# Site Accessibility Evaluation

### Fire Station 18

Accessibility Evaluation

SUBJECT: Fire Station 18 Self-Evaluation

**Finding: 2**

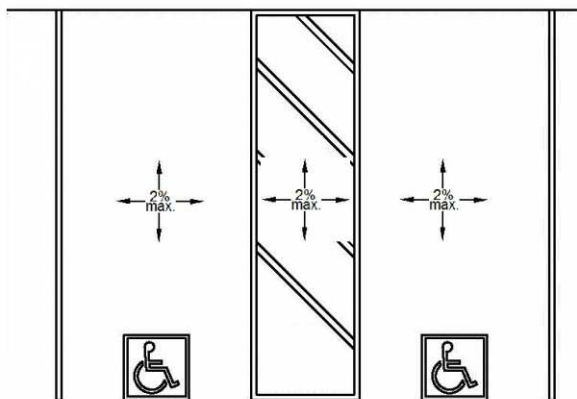
The accessible parking stall's access aisle contains a built up curb ramp which results in significant slopes greater than 2 percent.

There is a ramp in the access aisle.

Move the ramp to the sidewalk area.

**Finding: 3**

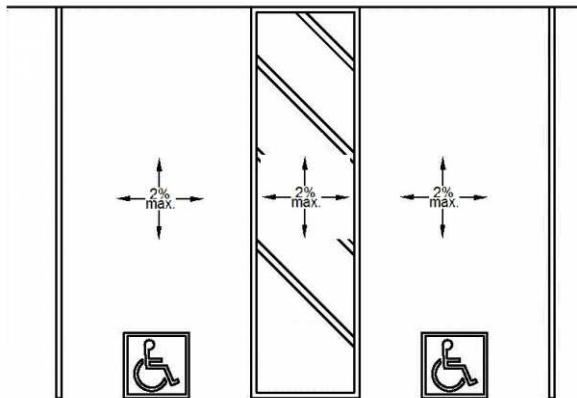
The cross slope (narrow dimension) of the parking stall exceeds 2%.

The cross slope in the accessible parking is 3.5%.

Replace the pavement so the cross slope is 2% maximum or as close to this as is feasible.

Finding: 4

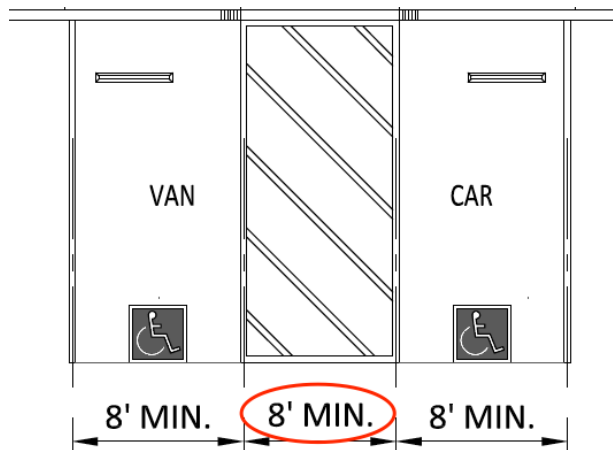
Since there is only one accessible parking space, it should be van accessible. This requires the parking space to be 8'-0" wide with an 8'-0" wide access aisle, or an 11'-0" wide space with a 5'-0" wide access aisle.

There is only one accessible parking space, and the access aisle is 6'-8".

Explore ways to make the access aisle wider.

### Finding: 6

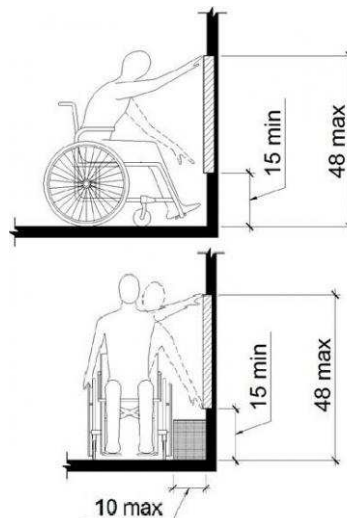
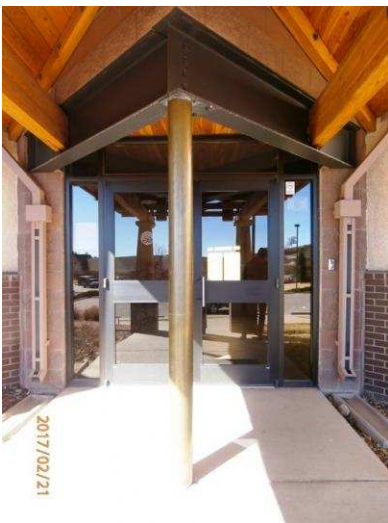
The door bell is positioned too high for either a side or front approach.

The door bell is mounted at 50".

Lower the door bell to 48" maximum.

**Finding: 7**

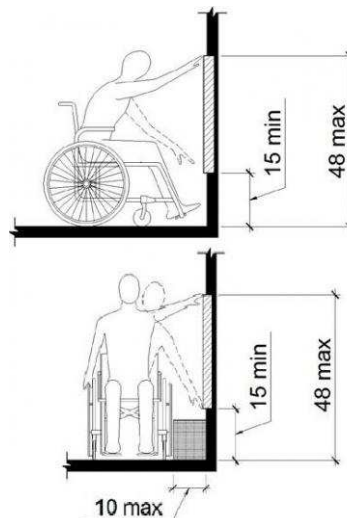
The door bell is positioned too high for either a side or front approach.

The interior door bell is mounted at 50".

Lower the door bell to 48" maximum.

### **Finding: 8**

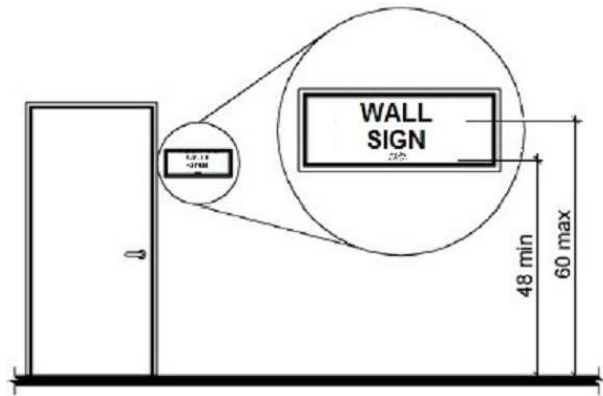
Compliant room identification signs are missing on the strike side of the door.

**There is not a sign at the interior door to the fire station.**

**Install a sign with tactile/Braille.**

### Finding: 9

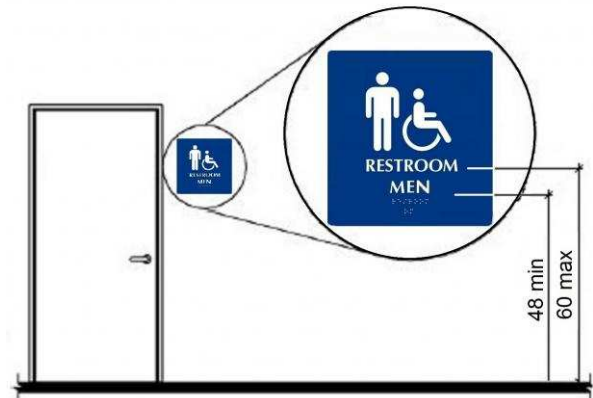
The wall sign is mounted too high.

The restroom sign is mounted at 61".

Lower the sign to 60" to the top edge.

**Finding: 10**

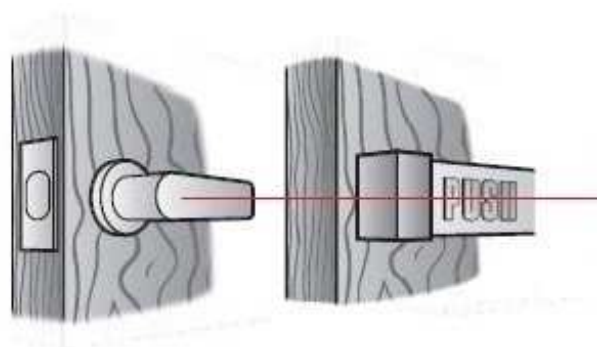
The force required to operate the door hardware exceeds the maximum.

The restroom door requires 13 lbs of force to open.

Adjust the door closer to 5lbs maximum.

### Finding: 11

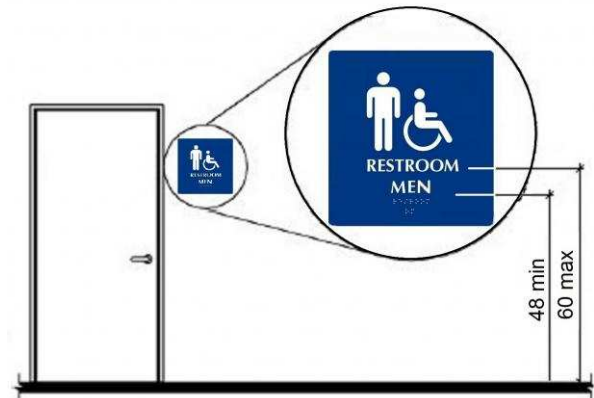
The wall sign is mounted too high.

The restroom sign is mounted at 61".

Lower the sign to 60" to the top edge.

### Finding: 12

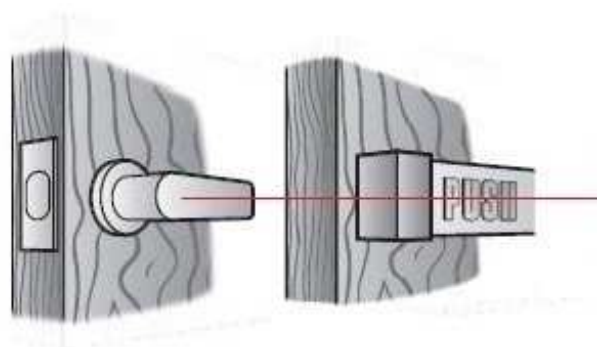
The force required to operate the door hardware exceeds the maximum.

The restroom door requires 9 lbs of force to open.

Adjust the door closer to 5lbs to the top edge.

### **Finding: 13**

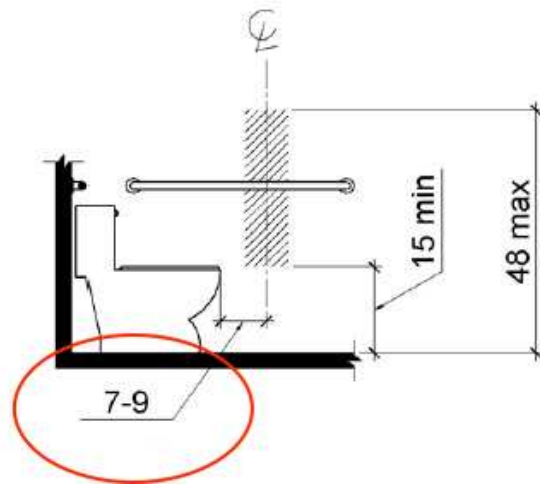
The toilet paper is not installed within the compliant range.

**The toilet paper dispenser is mounted 4" from the front of the toilet.**

**Move the toilet paper dispenser to 7 to 9" from the front of the toilet.**

### Finding: 14

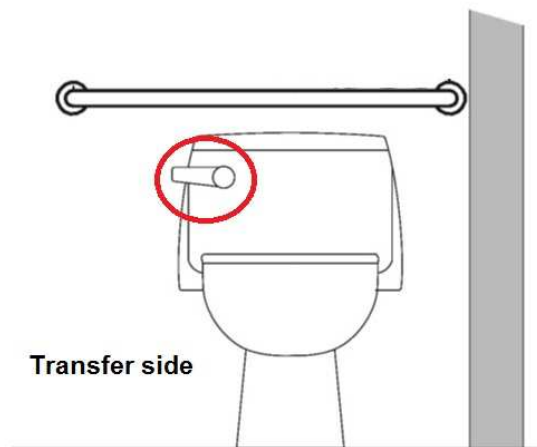
The flush handle is located on the wrong side of the toilet.

The flush handle is on the wrong side of the toilet.

Replace the tank so the flush handle is on the open side of the toilet.

**Finding: 16**

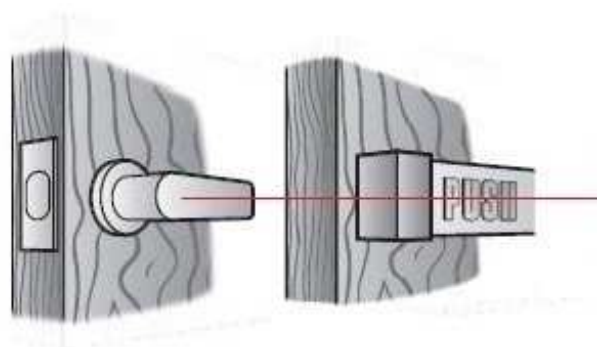
The force required to operate the door hardware exceeds the maximum.

The doors into the community room require 9 and 10 lbs of force to open.

Adjust the door closers to 5lbs maximum.
